# Technical Service Bulletin

Jackson WWS Service Bulletin No: 2016-1-SB

Subject: 8-Cam Mechanical Timers

Models Affected: Conserver XL-E, WF-I-E, WF-I-X

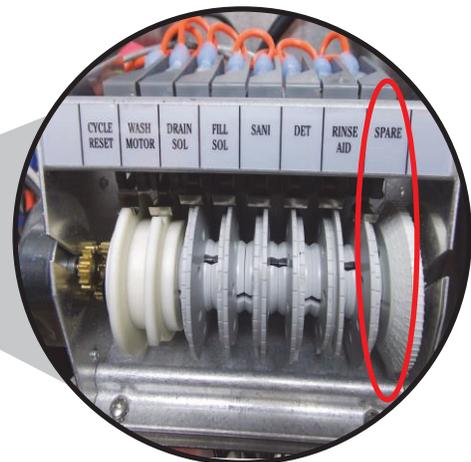
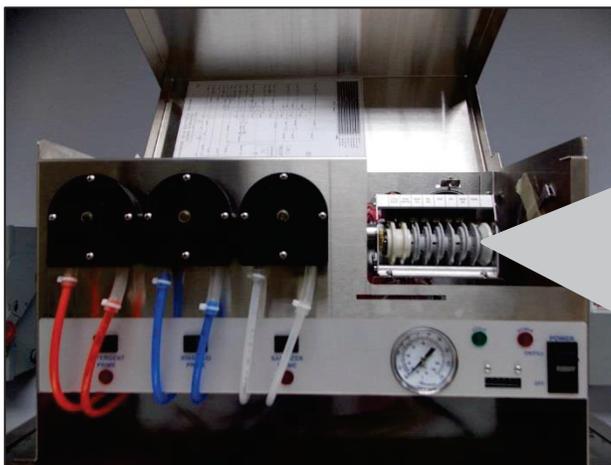
3. Locate the timer microswitch labelled "Spare" on the timer assembly.

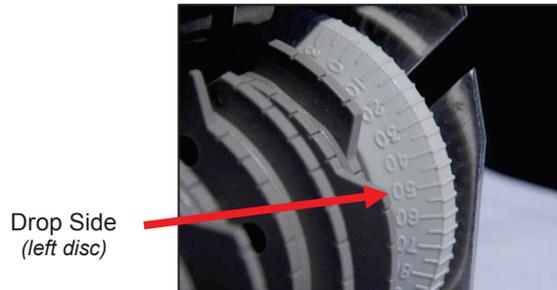
- Set the edge of the notch on the drop side of the cam to the 50-degree position. The drop side of the cam is the disc located closest to the timer motor, or to the left as you look at the front of the unit.

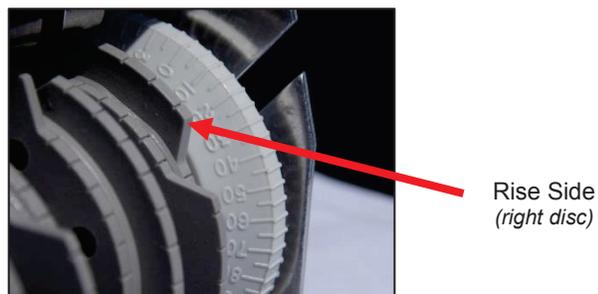
- Next, set the rise side of the cam to the 20-degree position.

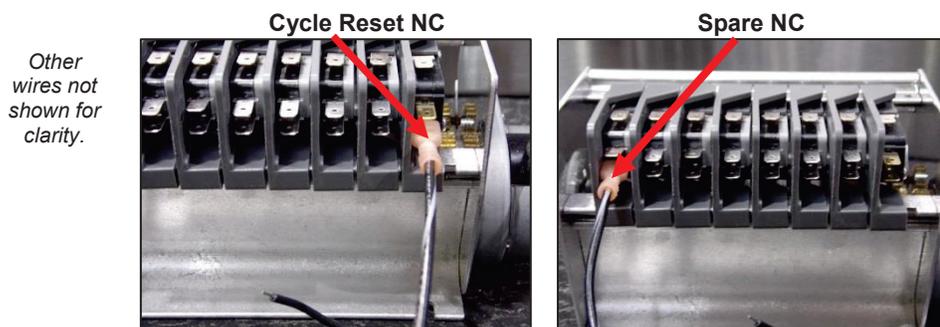
- On the back of the timer assembly, remove the Black and White wire from the NC position on the "Cycle Reset" microswitch and place it on the NC position on the "Spare" microswitch.
